Orlando Utilities Commission
Stanton Energy Center, Unit 1
Draft Conditions of Certification

B&V Project 8927
B&V File 8927.32.0203
February 12, 1982

Figure 1. Limestone back-filled drainage system.

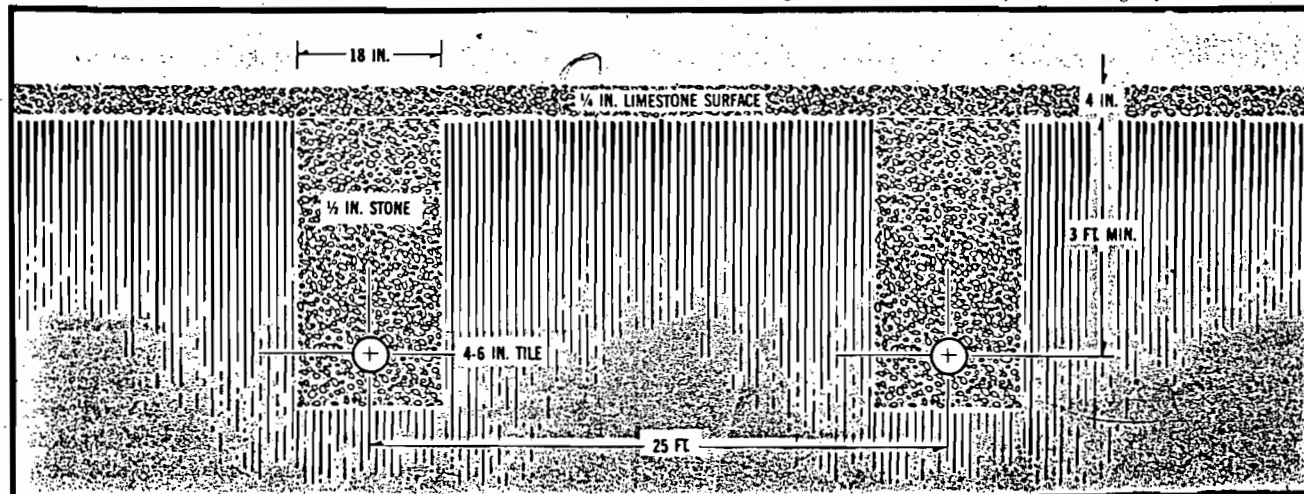
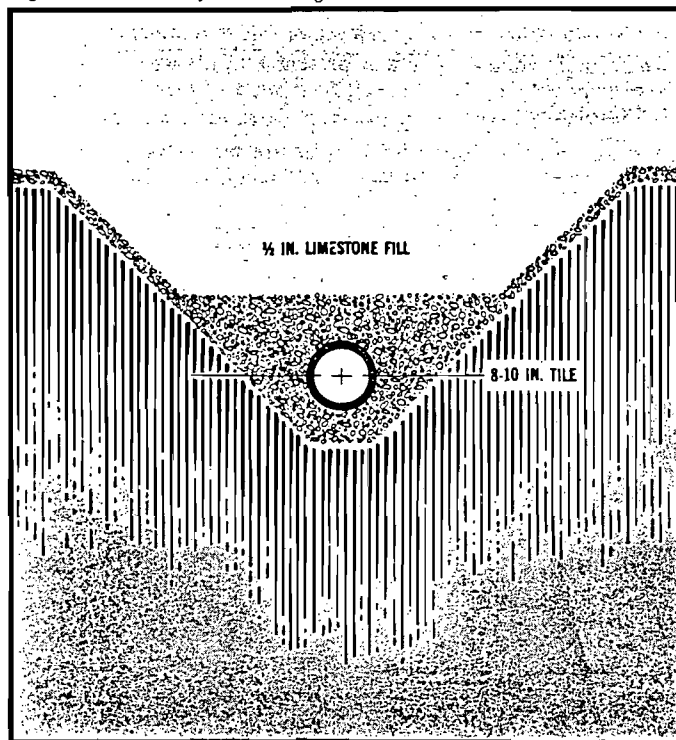
Sulfur in coal exists in the form of pyrites and organic compounds in relatively equal proportions. The pyrites readily undergo oxidation in the presence of moisture and oxygen, swell and cause the coal to fragment. The exothermic nature of the reaction in combination with increased coal particle surface area and oxidation rate result in the buildup of heat and contribute to spontaneous combustion.

Sulfuric acid and iron sulfates are formed and washed onto the surface of the coal storage area together with unreacted pyrites where they accumulate in the coal slack. The ferric sulfate reacts further with pyrite at low pH in an aqueous solution in the slack to form ferrous sulfate.

Caustic soda, soda ash, slaked lime, magnesium carbonate and limestone can each be used for neutralization. In the case of limestone a large surplus must be used to compensate for its lower reaction rate.

In the case of high calcium limestone and lime, all of the sulfates are precipitated out in the form of calcium sulfate, as contrasted with dolomitic limestone where half is in the form of soluble magnesium sulfate.
